UNITED STATES OF AMERICA
NUCLEAR REGULATORY COMMISSION

In the Matter of
Southern Nuclear Operating Company
License Amendment Application for
Combined Licenses NPF-91 and NPF-92
Vogtle Electric Generating Plant Units 3 and 4
Docket Nos. 052-00025 and 052-00026;
NRC-2008-0252-0057

DECLARATION OF ARNOLD GUNDERSEN TO SUPPORT THE
PETITION FOR LEAVE TO INTERVENE AND REQUEST FOR HEARING
BY THE BLUE RIDGE ENVIRONMENTAL DEFENSE LEAGUE REGARDING
SOUTHERN NUCLEAR OPERATING COMPANY'S
VOGTLE ELECTRIC GENERATING PLANT UNITS 3 AND 4
REQUEST FOR LICENSE AMENDMENT AND EXEMPTION:
CONTAINMENT HYDROGEN IGNITER CHANGES (LAR-15-003)

Thermal Image of Radiation Leaking From Fukushima Daiichi Unit 3 Containment

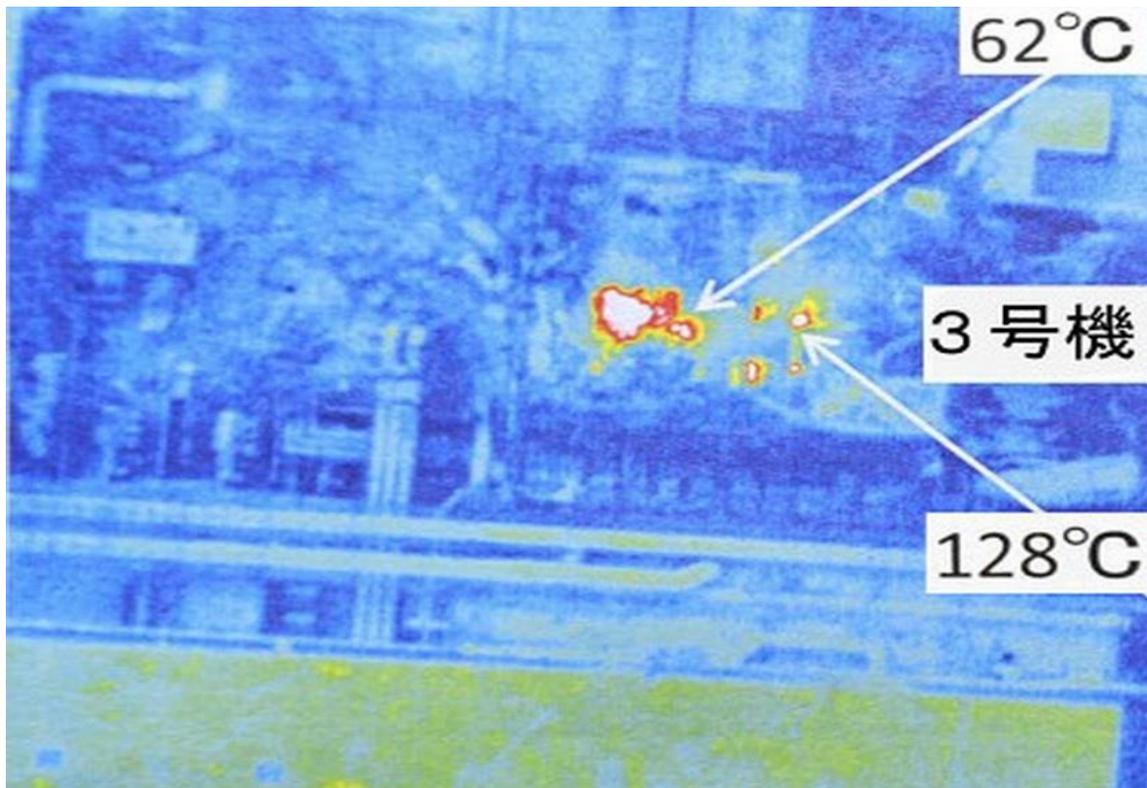
- 34.3. Below is a infrared photograph of Fukushima Daiichi Unit 3 taken by TEPCO several weeks after Unit 3 was destroyed by a detonation shockwave.
 - 34.4. The reader is directed to the 128C gases being vented at the center of the photo. This cannot be steam, as it exceeds 100C and must therefore be hot radioactive gases being released directly from the top of the containment.

34.5. The AP1000 containment could react in a similar fashion if the proposed hydrogen igniters are installed.

34.6. This exemption request is an unanalyzed condition that significantly compromises plant safety.
